Access Compliance Report

Public Rights-of-Way

Intersection ID: 5407	Main Street: J_W_CLAY_BV	Cross Street: J_M_KEYNES_DR	Location: S
ADA ID: 0F616659E4A7	Ramp Type: Perp	Initial Pass/Fail: Fail	Overall Compliance: No
		Severity Score: 12.5

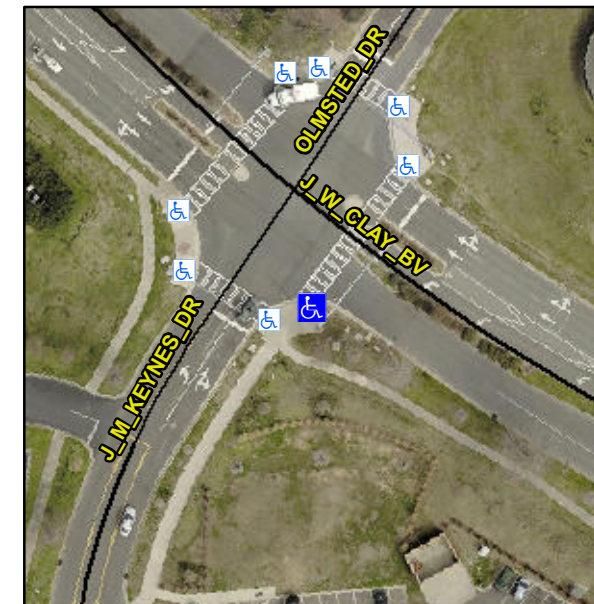
R304.2.2

Compliance	Description	Data	Compliance	Description	Data
N/A	Ramp Length (in)	95.0	No	Ramp Slope (%)	11.2
Yes	Ramp Width (in)	48.0	Yes	Ramp XSlope (%)	0.7
N/A	Flare Type LT	N/A	N/A	Flare Type RT	N/A
N/A	Flare Slope LT (%)	N/A	N/A	Flare Slope RT (%)	N/A
N/A	Flare Traversable LT?	N/A	N/A	Flare Traversable RT?	N/A
N/A	Landing Length (in)	N/A	N/A	DWS Provided?	N/A
N/A	Landing Width (in)	N/A	N/A	DWS Contrast?	N/A
N/A	Landing Slope (%)	N/A	N/A	DWS Length (in)	N/A
N/A	Landing X Slope (%)	N/A	N/A	DWS Full Width?	N/A
N/A	Landing Curb? (Y/N)	N/A	N/A	DWS Offset (in)	N/A
N/A	Shared Landing?	N/A			
N/A	Gutter Ponding?	Yes	N/A	Gutter Slope (%)	N/A
N/A	Gutter Lip Ht (in)	N/A	N/A	Gutter X Slope (%)	N/A
N/A	Painted X Walk1?	No	N/A	Painted X Walk2?	N/A
	X Walk 1 Direction	To NE		X Walk 2 Direction	N/A
N/A	X Walk 1 Width (in)	N/A	N/A	X Walk 2 Width (in)	N/A
	X Walk 1 Slope (%)	1.2		X Walk 2 Slope (%)	N/A
	X Walk 1 X Slope (%)	0.5		X Walk 2 X Slope (%)	N/A

Remove & Replace Entire Ramp.
